RE: Response to Teleconference Comments
Mary River Project - Modification Request No. 12
Type 'A' Water Licence - 2AM-MRY1325 - Amend. No. 1

Baffinland Iron Mines Corporation (Baffinland) provides the responses below to comments received from Crown-Indigenous Relations and Northern Affairs Canada (CIRNAC) and the Nunavut Water Board (NWB), regarding Water Licence Modification Request No. 12. These comments were received during the July 3, 2019 teleconference held regarding this Modification Request.

Figure 1-1: Milne Port Stockpile Areas

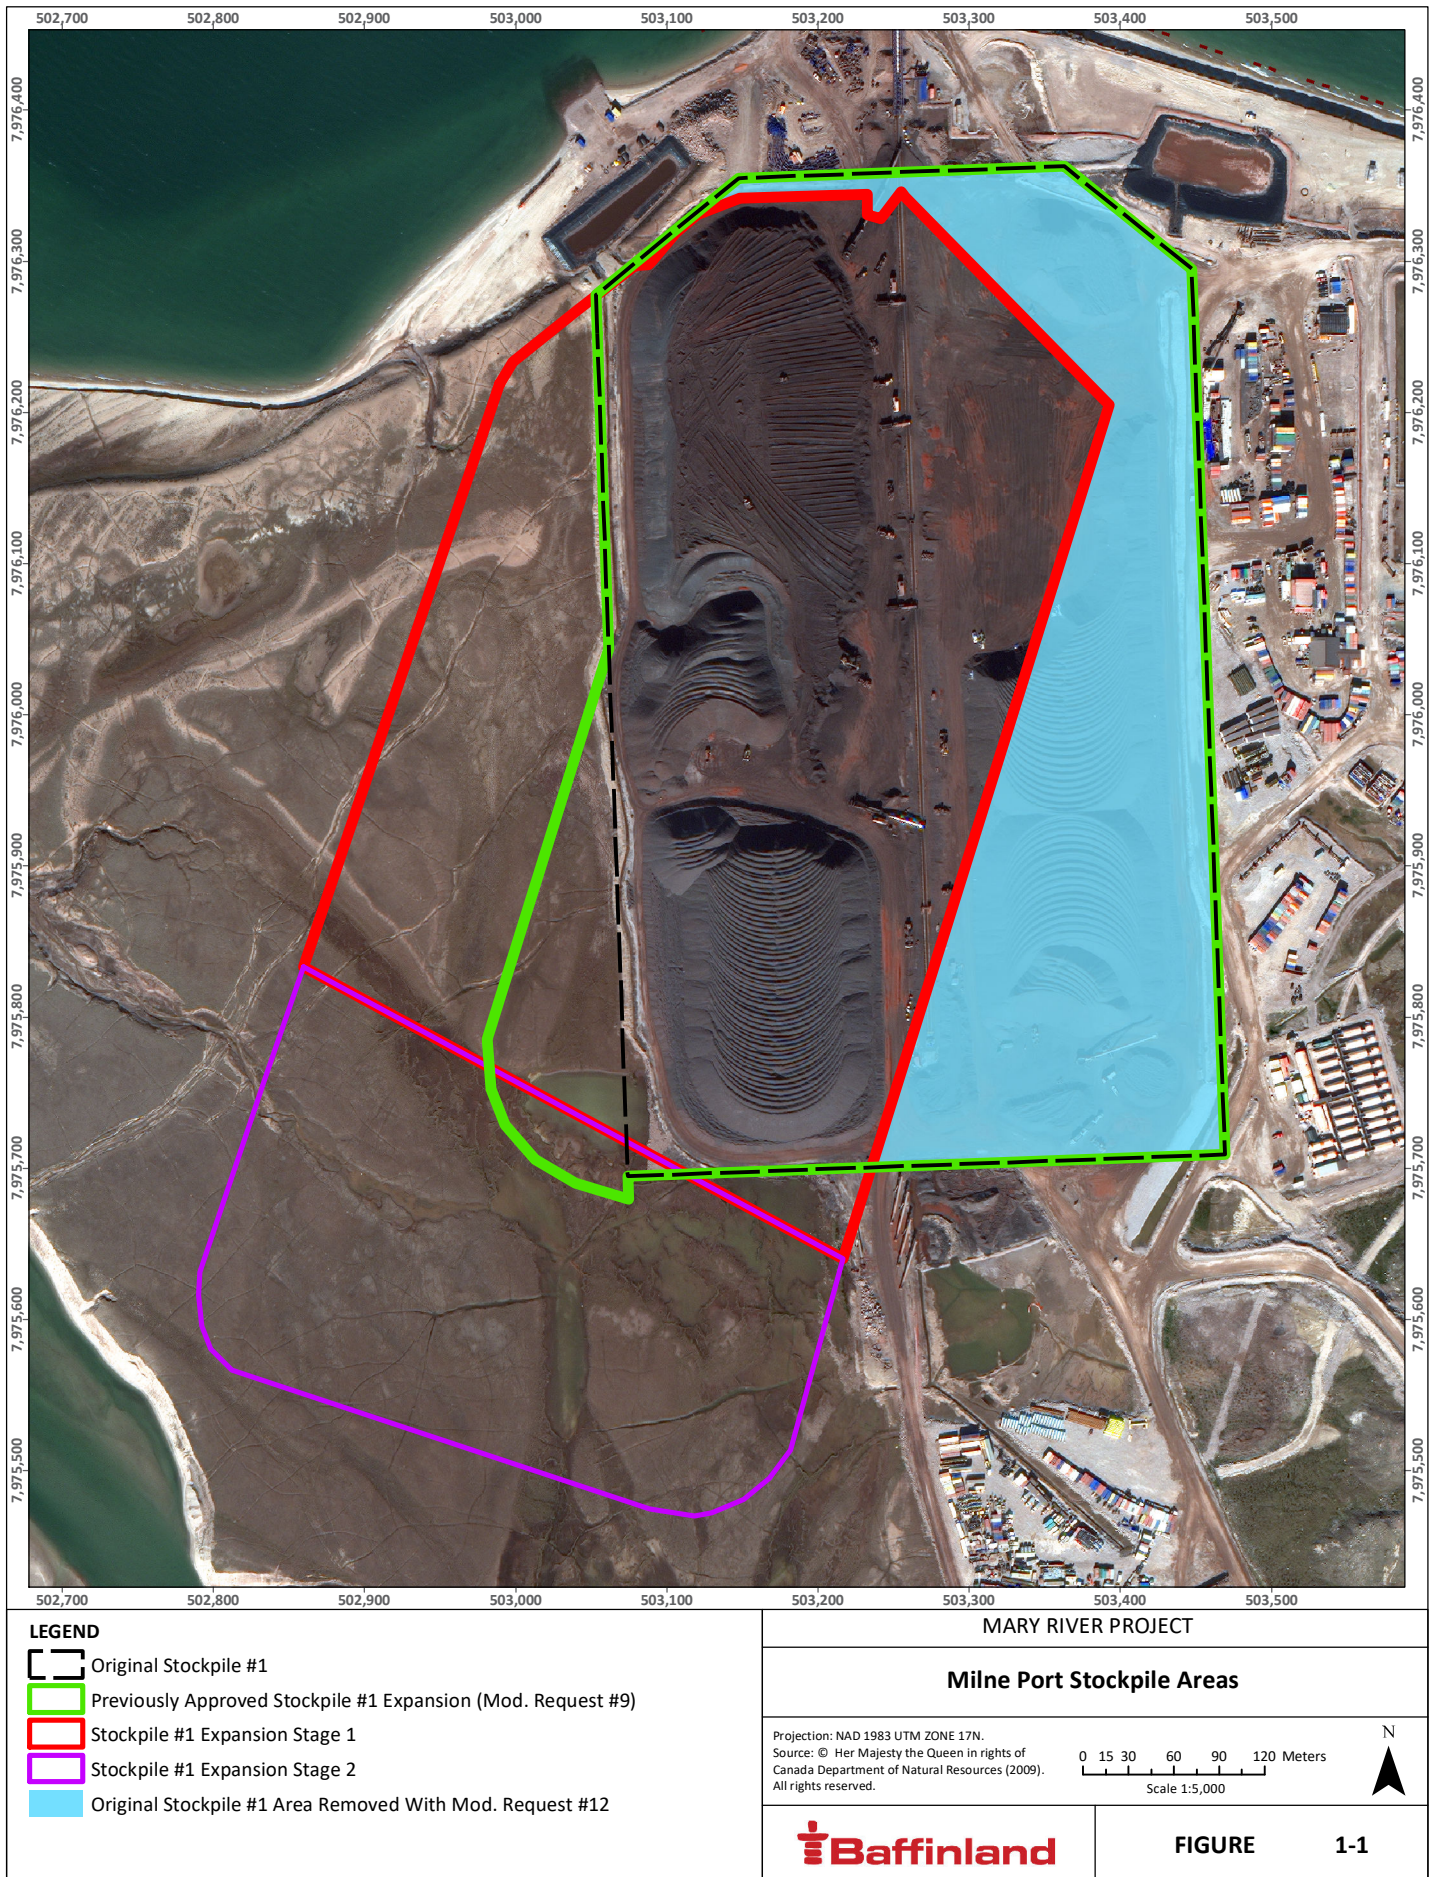
1. Further Justification for the Stage 2 Portion of the Stockpile Expansion

Stockpile #1 originally occupied an area of 25.32 ha, denoted by the dashed line on Figure 1-1 in Attachment 1. Water Licence Modification Request #9 subsequently allowed an increase in the area of Stockpile #1 to 27.22 ha, denoted in green on Figure 1-1.

Stage 1 of the Stockpile #1 expansion will occupy an area of 23.11 ha, denoted by the red line on Figure 1-1. Stage 2 will occupy an area of 9.23 ha, denoted by the purple line on Figure 1-1, for a total available stockpile area following completion of 32.34 ha. Also denoted on the map is an area of the original stockpile footprint which will no longer be usable for ore stockpiling as a consequence of realigning the stockpile and conveyor, which is 9.26 ha and denoted in blue on Figure 1-1.

Additional stockpile space is required to allow Baffinland to (i) create multiple customer-owned piles, and (ii) provide for sufficient separation between the piles to ensure no co-mingling of different buyer's products. As the volume of ore shipments has increased, customer demand for maintaining separate stockpiles has also increased. Maintaining separate stockpiles reduces stockpiling efficiency as it reduces the height of potential stockpiles, thus requiring greater surface area to store a comparable amount of

ore. As well, to access each stockpile, pathways of sufficient size to accommodate heavy equipment must be maintained, further reducing available stockpile area.

It is further noted that the Stage 1 area is smaller than original stockpile footprint that was available prior to the expansion in Modification Request #9. Construction of both the Stage 1 and Stage 2 areas is essential to allow for efficient bulk material handling.
